SPRINGS HILL WATER

RE: Comments on Initially Prepared 2011 South Central Texas Regional Water Plan

Recommended Regional Pipeline Alignments

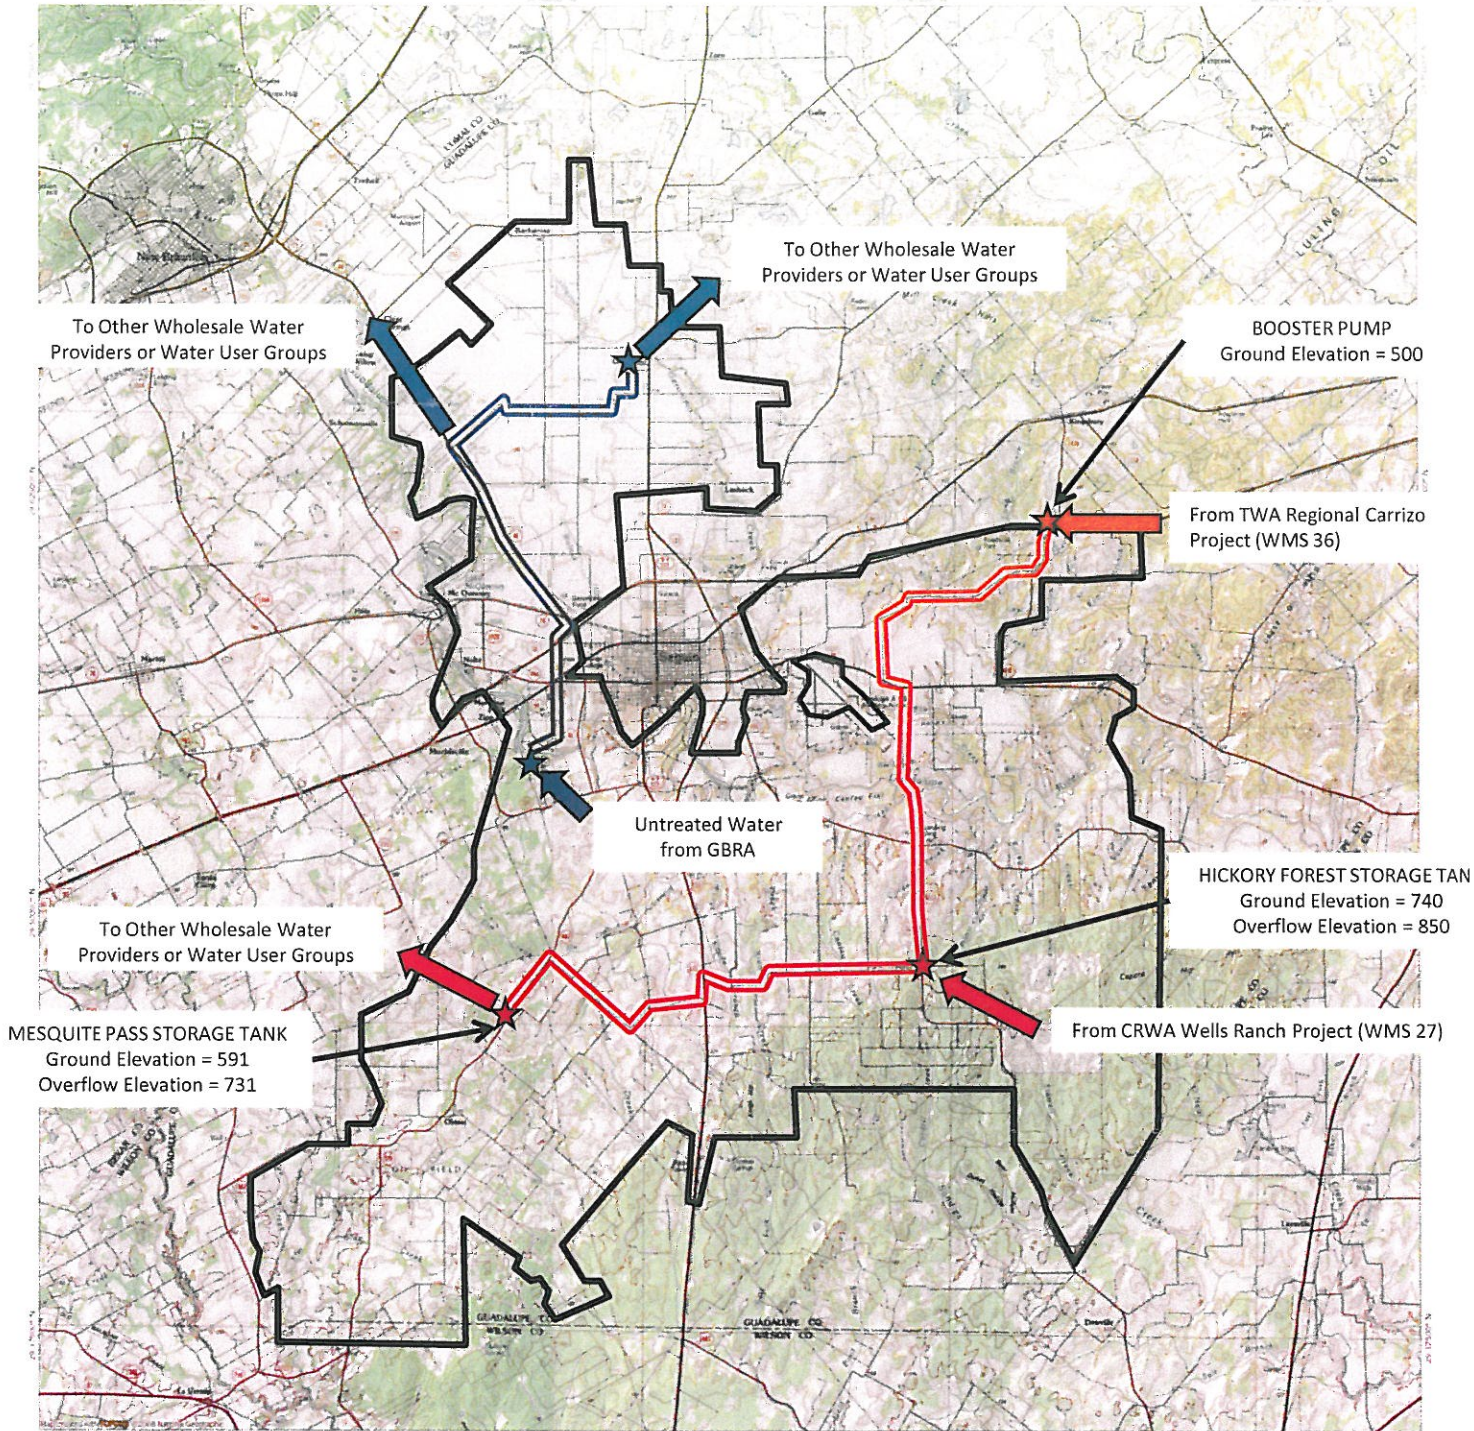
In order to meet its forecast surface water shortages SHWSC recommends that one of the adopted GBRA Water Management Strategies ("WMS") include a GBRA water pipeline that delivers untreated water to the SHWSC Lake Placid Treatment Plant. The SHWSC Lake Placid Treatment Plant would be expanded. A regional potable pipeline would transport treated water from the SHWSC Lake Placid Treatment Plant to both the Hwy 46 Corridor and the Hwy 123 Corridor north of Seguin. The conceptual alignment of this proposed pipeline is shown on the attached figure.

In order to meet its forecast groundwater shortages, SHWSC recommends that the TWA Regional Carrizo Project (WMS 36) pipeline deliver water to the SHWSC Hickory Forest Elevated Storage Tank. SHWSC also recommends a single regional pipeline be constructed from the SHWSC Hickory Forest Elevated Storage Tank to the SHWSC Mesquite Pass Elevated Storage Tank. This single pipeline will transport potable water from both the TWA Regional Carrizo Project (WMS 36) and the CRWA Wells Ranch Project (WMS 27). The general alignment of this proposed pipeline is shown on the attached figure.
